Memo

Subject Addendum to the Stormwater Management Strategy –Regional Park Scenario
Distribution David Portelli (VPA)
Date 29 August 2017
Project McPherson PSP

This addendum is provided to supplement Alluvium’s previous *Stormwater Management Strategy – McPherson Precinct Structure Plan (PSP 1055)* (Alluvium, 2016).

Figure 1. a) Previous draft alignment (suggested by Melbourne Water), b) alignment with sharp curve (current PSP alignment), c) updated splay allowing channel radius of curvature of 75m.

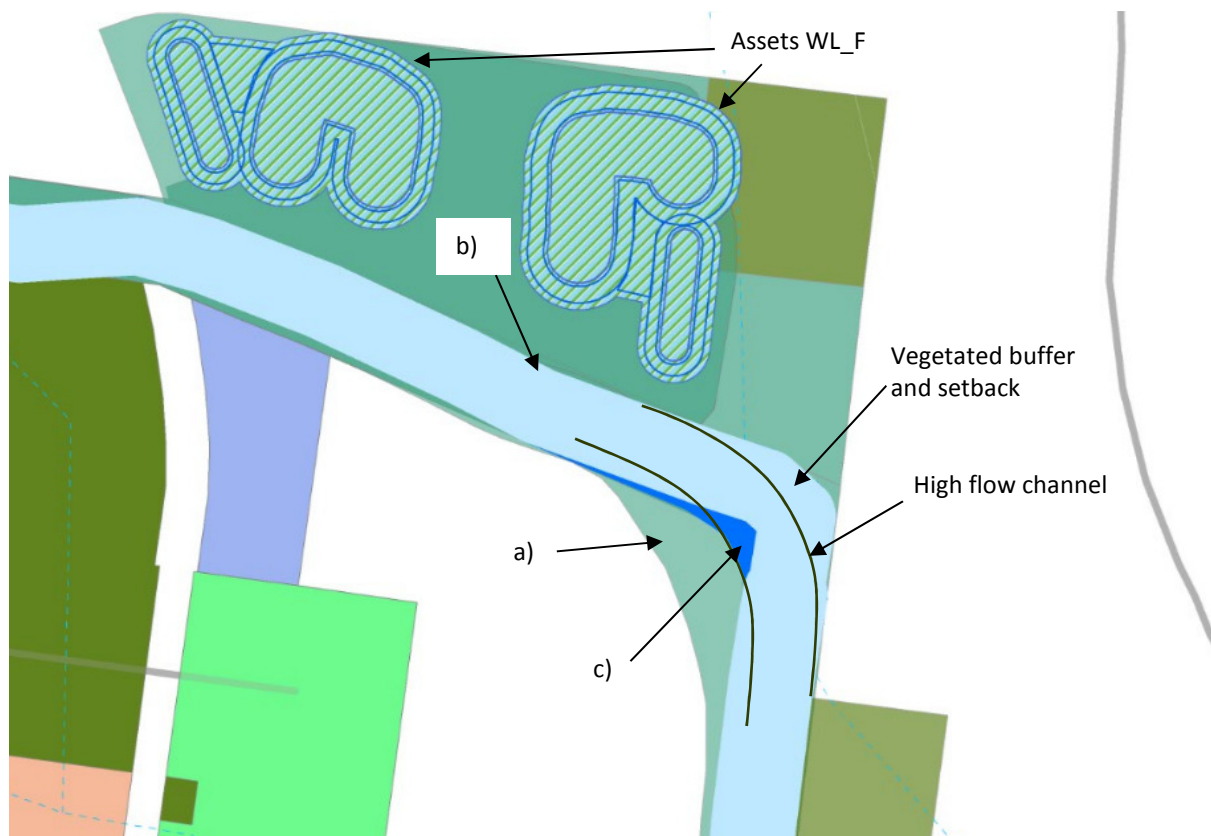
In the original strategy, the constructed waterway in the Baillieu Creek area featured a sharp bend toward the centre of the site. Some concerns were raised by Melbourne Water as to potential high velocities and shear stresses at the location of the bend. Melbourne Water suggested their preference was for a gentler bend in line with previous draft versions of the strategy.

A review of the bend has been undertaken in line with the draft version of Melbourne Water’s Constructed Waterway Design Manual. The manual describes appropriate design considerations for channel bends in section 3.3.3 of *Part D: Reach-scale Functional Design*. Bend sharpness is defined as the ratio of the bend radius of curvature to channel width:

Bend sharpness should generally be in the range of 2-3 for constructed waterways. Sharper bends for sections of relatively uniform cross-section can lead to flow separation and increased energy losses.

The total constructed waterway corridor includes the core riparian zone and the vegetated buffer in addition to the waterway channel itself. Since constructed waterways are typically designed with some sinuosity in both the low and high flow channels, the actual channel planform can be curved around sharper sections of the total corridor. The proposed waterway corridor at the location of the tight bend has a hydraulic width of 33m. A small splay has been added to the southern boundary of the corridor at this location to allow a radius of curvature of approximately 75m in the high flow channel. The resulting bend sharpness is 2.3, within the acceptable range. Figure 1 demonstrates this arrangement.
